General comment: The FS The Wyoming 309(g) RH SIP is a detailed document which addresses all of the requested elements outlined in our letter dated 8/2006. Nevertheless, we have concerns regarding some technical approaches and policy considerations as outlined below.

Section 7.6

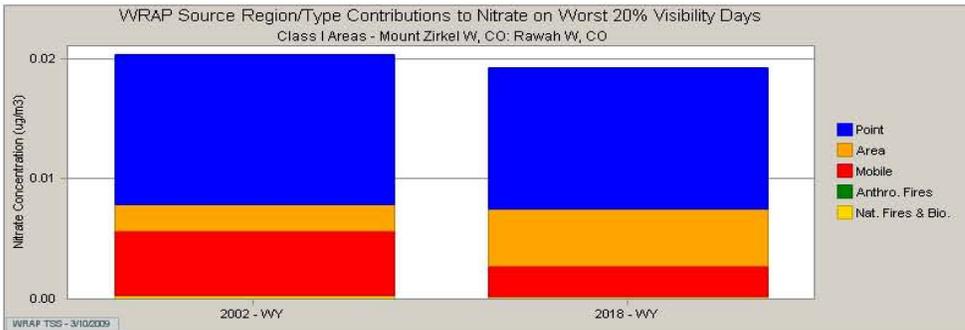
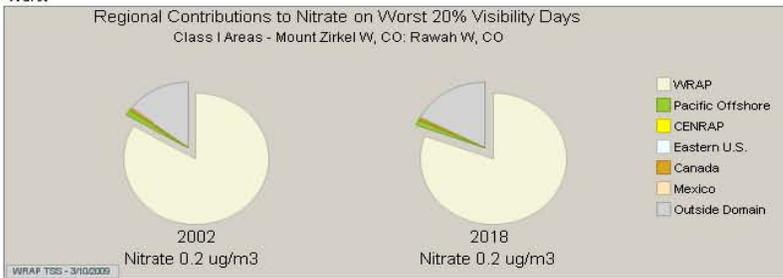
1. Neff, et al. 2008, suggest that roughly 75% of windblown dust is attributable to human activity. As such, it is not appropriate to suggest that windblown is a reason for failure to achieve the URP.
6. While it is true that Western Class I areas are cleaner than their Eastern counterparts, that can make it *less difficult* to show improvement. That is, cleaner air is *more* sensitive to changes in pollution. This is why it is important to consider visibility impacts (e.g. \$/dv) when determining control strategies.

Wyoming Nitrate Contribution to Mount Zirkel

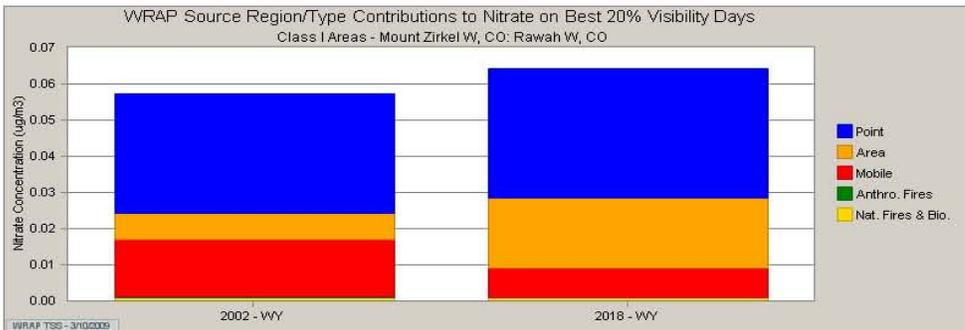
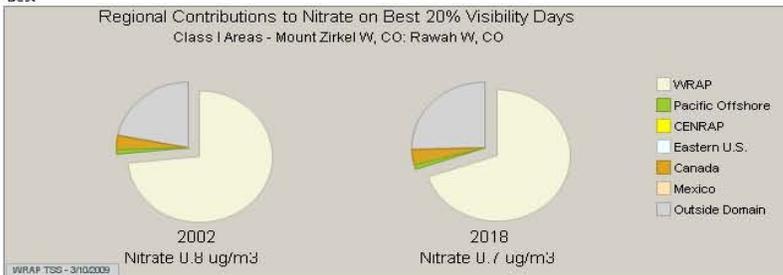
Wyoming's 2002 Contribution (20% Worst) to Nitrate at Mount Zirkel = 0.02 divided by 0.2, or 10%

Wyoming's 2002 Contribution (20% Best) to Nitrate at Mount Zirkel = 0.06 divided by 0.8, or 8%
